# KENWOOD

SB-925

## SERVICE BULLETIN AMATEUR RADIO

SUBJECT	DATE
TM-3530A NOISY TRANSMIT	11/02/87

FIGURE 1

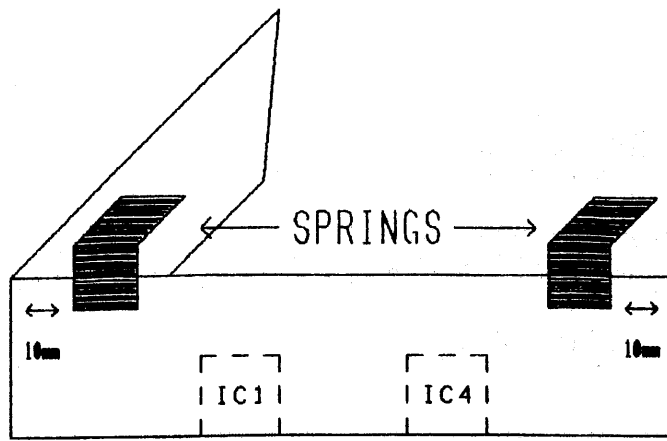
1. Disconnect the power cord and antenna.
2. Remove the top and bottom covers.
3. Replace L3 on the Compound unit (part number L15-0308-05). Before soldering the coil to the board, place a drop of contact or silicon glue under the coil to prevent mechanical vibration.
4. On the Compound unit, solder two springs (part number G02-0550-04) to the heat sink as shown in figure 1. The springs must be mounted high enough to make firm contact with the top cover when installed.
5. On the PLL unit, solder a spring (part number F10-1206-04) to the TX VCO shield (see figure 2). The spring must make firm contact with the bottom cover when installed.

FIGURE 3

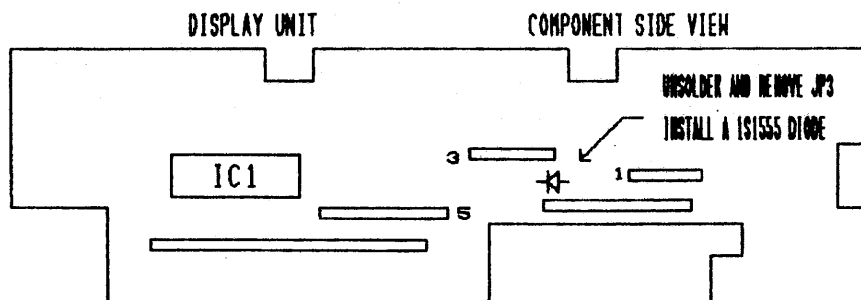
6. On the Display unit, replace jumper JP3 with a diode (part number 1S1555) as shown in figure 3.
7. Reassemble the transceiver and test the modulation for correct adjustment:
  1. Apply a 1KHz, 50mV signal to pin 1 of the mic jack.
  2. Turn VR7 on the Compound unit fully CCW.
  3. Use a service monitor, linear detector, or deviation meter to measure the TX deviation at the antenna jack.
  4. Adjust VR5 on the compound unit for +/-4.5KHz.
  5. Reduce the mic signal to 5mV. Adjust VR7 for +/-3.0KHz.
